UNITED STATES PATENT AND TRADEMARK OFFICE

APPLICATION NO.	FILING DATE	FIRST NAMED INVENTOR	ATTORNEY DOCKET NO.	CONFIRMATION NO.
09/932,539	08/17/2001	Gavin J. McIntosh	FMCE-P064	3957

Office Action Summary

DETAILED ACTION

Fig. 3A

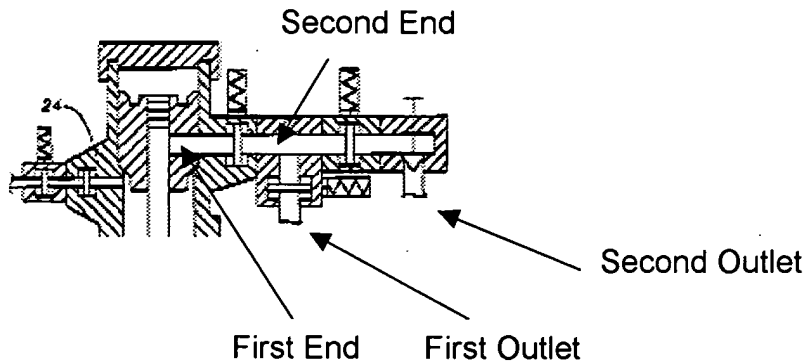
2. Claims 1, 3, 6-8, 10 and 13 are rejected under 35 U.S.C. 102(e) as being anticipated by Hopper *et al.* With particular reference to drawing Figure 3A combined with lines 51-67 and 1-7 of respective columns 4 and 5, Hopper *et al.* disclose, *inter alia*, a horizontal christmas tree (24) with vertical completion tubing *or* production bore (21) landed therein for production. As clearly shown by the illustration, the vertical completion tubing *or* production bore (21) is connected to a horizontal production bore, which contains two production outlets; moreover, drawing Figure 3A clearly depicts respective valve members on each of the two production outlets. Regardless, production of oil via tubing necessitates various types of valve members. The Examiner has provided Applicant with a facsimile of Hopper *et al.*'s drawing Figure 3A for convenience. Additionally, the Examiner has provided elucidating arrows on the figure

noted *supra* that indicate the first and second ends of the horizontal bore as specifically called for in Applicant's recently amended claim 1.

Thus, the production from the first end to the second follows a particular course of action; however, the particular course of action is disrupted upon reaching the second end—the course of action clearly changes as shown in the drawing figure.

Regarding Hopper *et al*, applicant notes in lines 2-3 of page 2 that Hopper does not disclose the function of the various conduits depicted in Figure 3. Subsequently, applicant alleges in the third paragraph of page three that tree (24) contains a singular production outlet. Specifically, applicant contends that examiner-labeled "Second Outlet" is the only production outlet in the tree (24) of Hopper. Furthermore, applicant maintains that examiner labeled "First Outlet" is a crossover line as opposed to a production outlet. The Examiner respectfully submits that it is known in the art to employ a crossover line as a production outlet. The patents to Mohn, Gould, Townsend, Jr., the patent application to DeBerry and the Foreign Search Report to Doyle *et al*. teach crossover lines as production outlets in horizontal trees. As an example, DeBerry depicts "Production crossover flow" in Figure A6 and teaches the same in the accompanying literature. With reference to paragraph [0031], production fluid flows up production tubing (22) and enters a crossover line (84) for recovery. Additionally, applicant is reminded if the prior art structure is capable of performing the intended use, then it meets the claim. See *In re Casey*, 152 USPQ 235 (CCPA 1967) and *In re Otto*, 136 USPQ 458, 459 (CCPA 1963).
